Attachment to Interview Summary

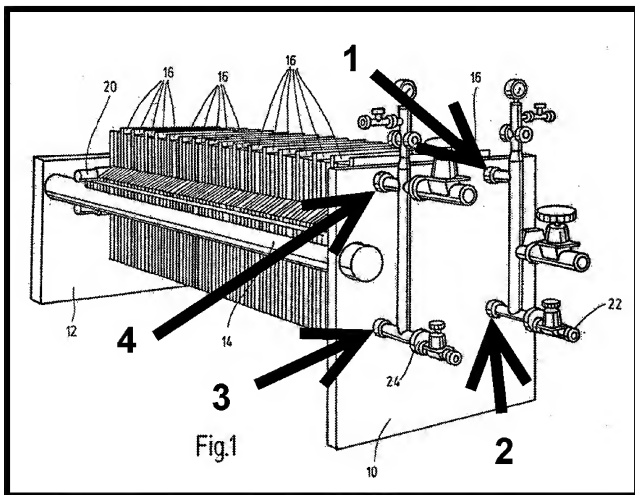
The undersigned contacted **Mr. Mark S. Bicks** on **December 2, 2010** in an effort to clarify operation of the claimed filter. Specifically, fluid communication between the **FOUR** unlabeled ports (see annotated Figure 1 below) in “**mounting plate**” **10** and the **SIX** orifices/ports (**38, 40** and **36** in the top; **38, 40** and **36** in the bottom) in the **frame 16** was questioned. **Figure 2a** (non-elected) was discussed by way of example.

Mr. Bicks expressed the belief that one of ordinary skill in the art would know that the ports 38 and 40, both being outlets or outputs, would somehow be connected. The undersigned did not concur. No agreements or promises were made.
